**Modification to MP 08_0069 Potts Hill
Stage 1 Civil Infrastructure Works Project Application**

We refer to the abovementioned Project Application for the Stage 1 Civil Infrastructure Works at Potts Hill (Bankstown LGA) approved by the Minister for Planning on 26 November 2008.

Attachment A – Profile of the proposed "Borrow Pit".

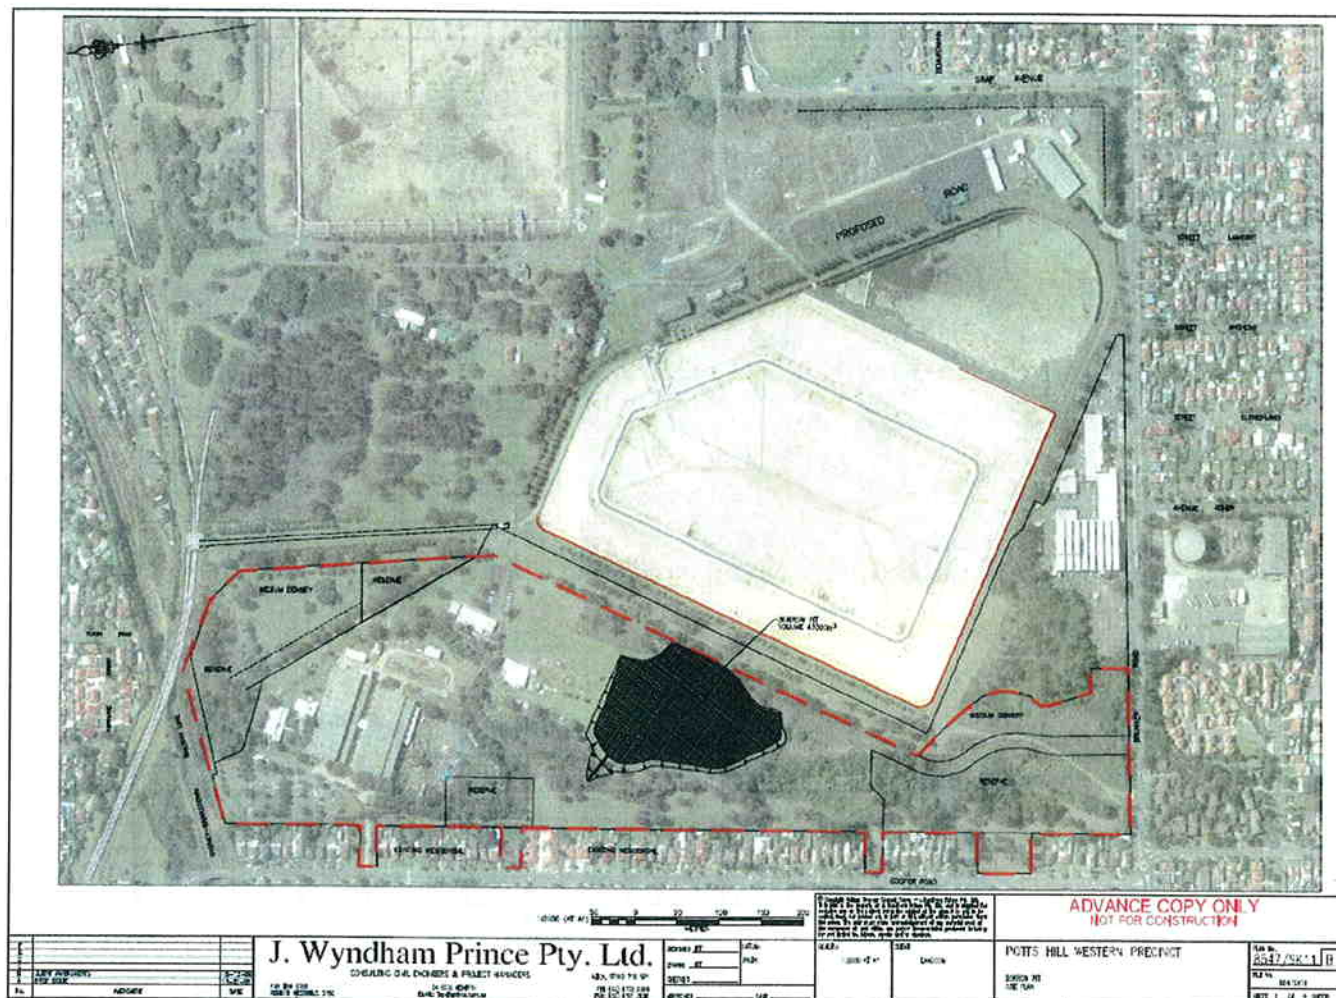
The approved earthworks will require the construction of a "borrow pit" of approximately 50,000m³ of soil which will be excavated from the Western Precinct and transferred to the Eastern Precinct.

The proposed dimensions and location of the borrow pit is shown on the plans prepared by J Wyndam Prince and are marked Attachments A and B respectively. It is located wholly within the land to which the approval of Project Application MP 08_0069 applies. The opportunity to source the material onsite within the western precinct and relocate to the eastern precinct will have minimal impact. The following assessment outlines those impacts.

Attachment B – Location of the proposed "Borrow Pit"

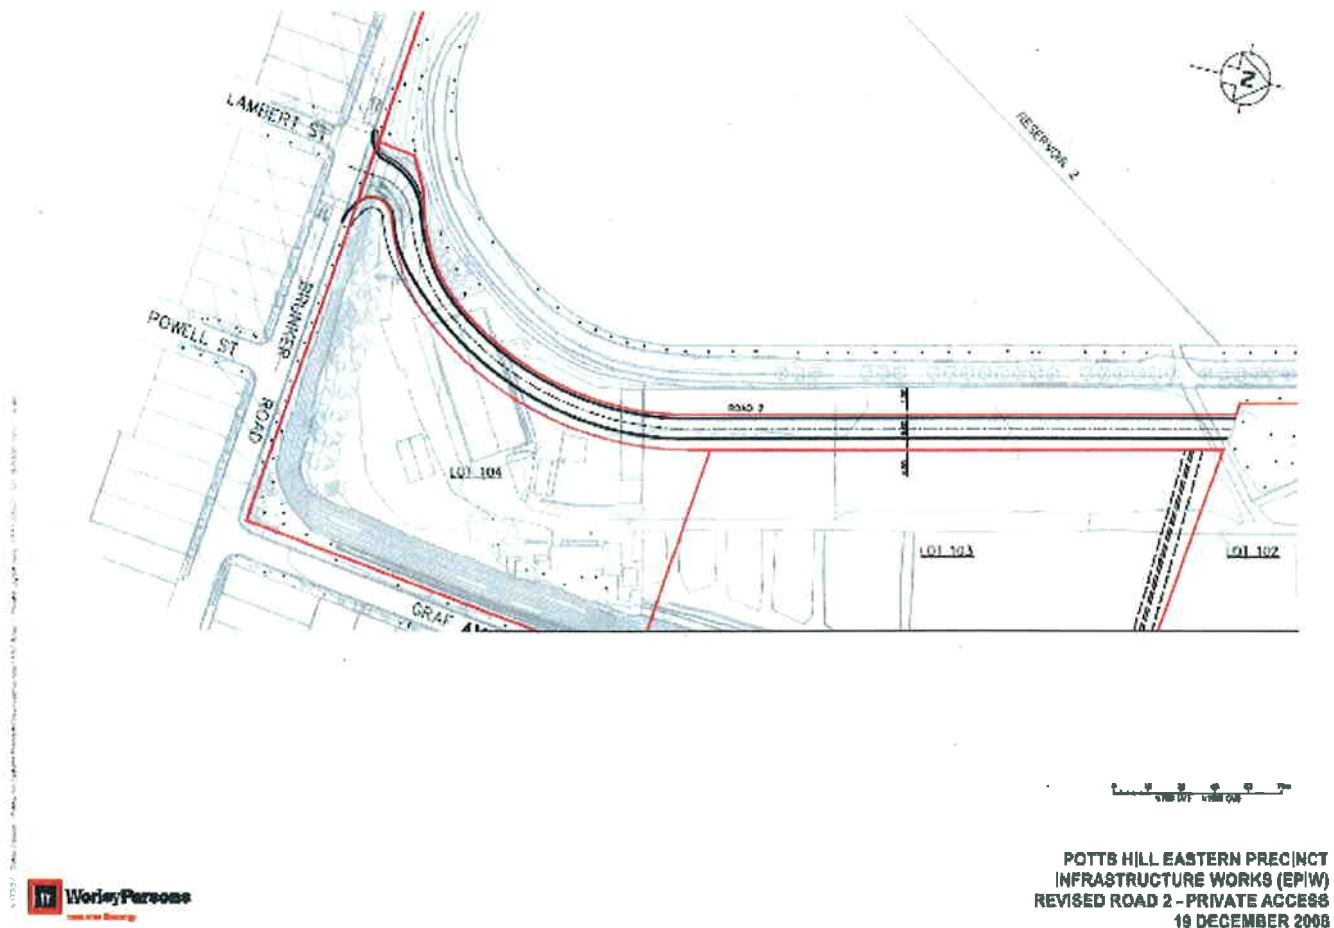
As indicated on the location plan for the borrow pit, the subject site does not contain any vegetation of significance, and as a result will not have any detrimental effects on the ecology of the site.

The borrow pit is located outside the revised State Heritage Register boundary recently approved by the Heritage Council. As a result, there will be no heritage impacts arising from the proposal.

Attachment C – Road 2 – Proposed Private Access

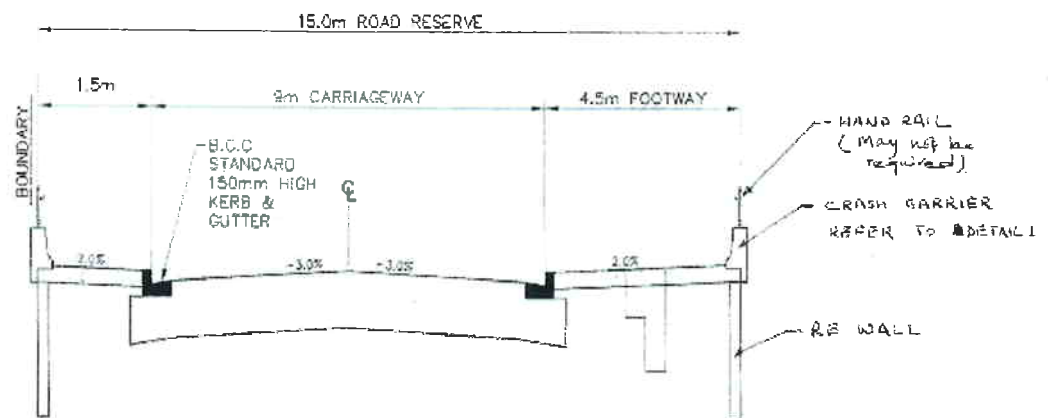
We therefore request that Condition 5 be modified to allow Road 1 and / or Road 2 to be constructed and operated as a private road(s) should Sydney Water Corporation choose to do so. Attachments C,D, and E are plans prepared by Worley Parsons illustrating the specifications to which one or both roads would be constructed if retained as private roads. The requested rewording of Condition 5 is as follows:

In the event that one or both access roads are retained in private ownership, they shall be constructed to the specifications identified in plans dated 19th December, 2008. Appropriate easements under Section 88B or 88E of the Conveyancing Act, 1919 shall be submitted with the final plan of subdivision demonstrating any necessary restrictive covenants, easements, and / or rights of way required to provide access to the lots within the subdivision."
